E8362B-02

S E R V I C E N O T E

E8362B PNA Microwave Network Analyzers

Figure 1: A3 Front Panel Interface Board Assy without the Bracket

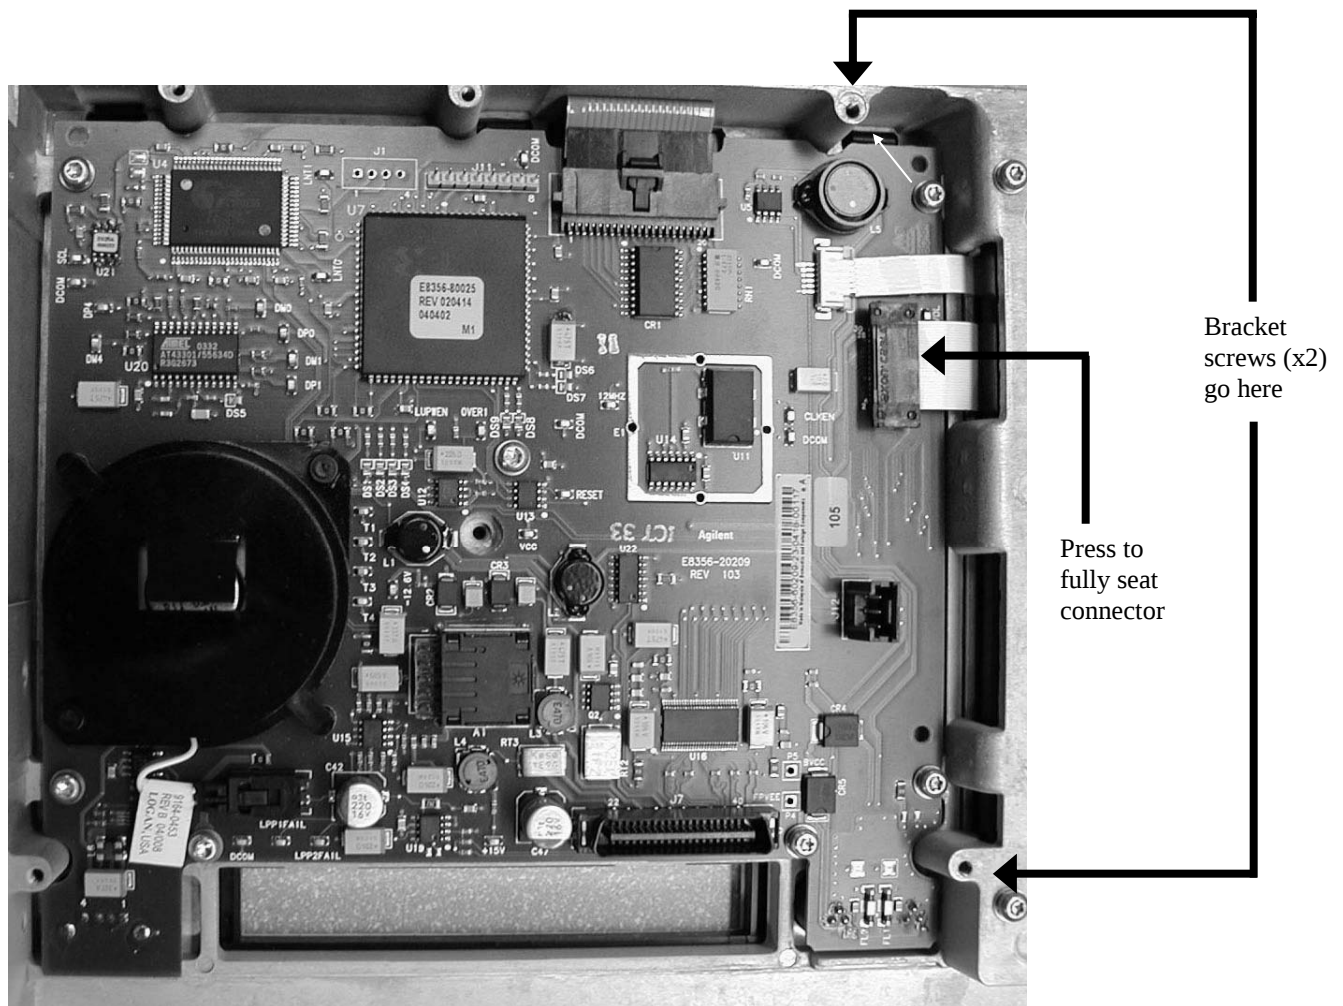
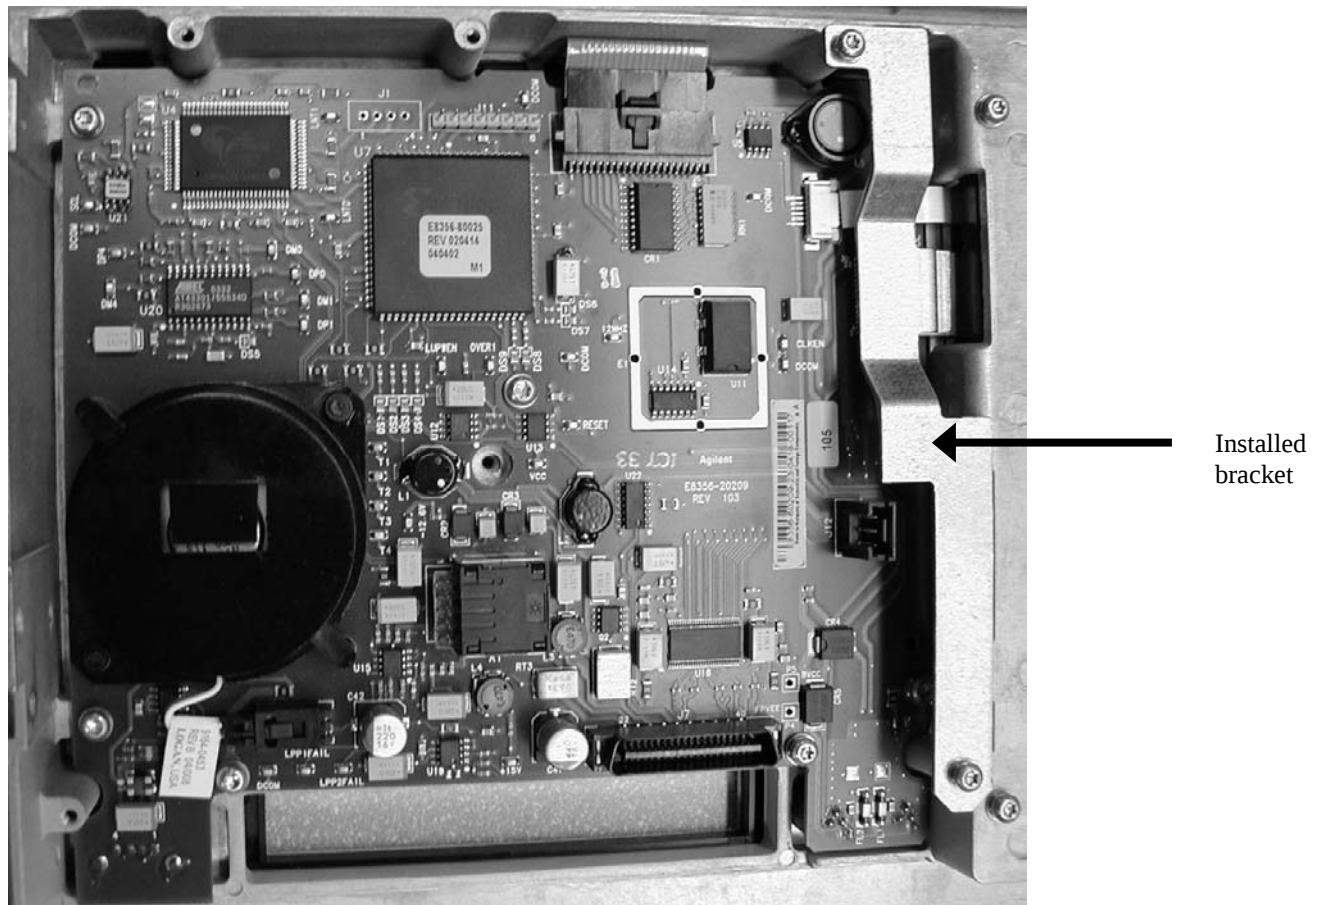
A connector of the ribbon cable (Agilent part number 8120-8409) that joins the front panel display to the front panel interface board can loosen, causing a display failure, unless a new bracket is installed. Because the failure rate has been very low, it is recommended that the bracket be installed only when there is an additional reason to remove the PNA front panel.

1. Refer to Figure 1 in this document:
 - Press down firmly on the ribbon cable's black connector.
 - Locate the two tapped holes for the bracket screws.
2. As shown in Figure 2 in this document, position the bracket so that its holes line-up with the two holes you located in the previous step.
3. Hand-start the two screws, and then torque both to 9 in-lbs.
4. Reinstall the PNA Front Panel by following the Service Guide instructions in the "Replacement Procedure." This is located on the same page as the "Removal Procedure" used previously in step 7.
